September 27th, 2024

MCQA-Ø150/Ø200、MCQV-Ø160 Profile change Notification

Before	After
<p>MCQA-Ø150/Ø200</p> 	<p>MCQA-Ø150/Ø200</p> 
<p>MCQV-Ø160</p> 	<p>MCQV-Ø160</p>

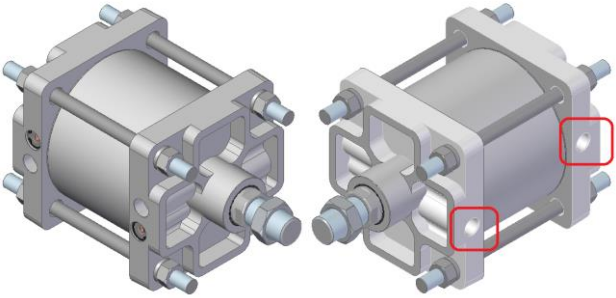
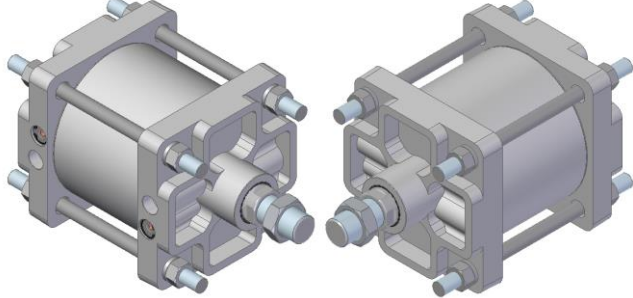
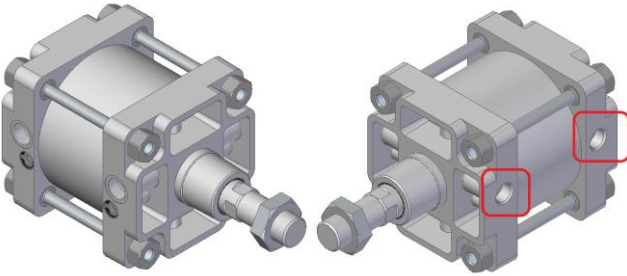
Change descriptions : Remove the reserved holes on the caps.
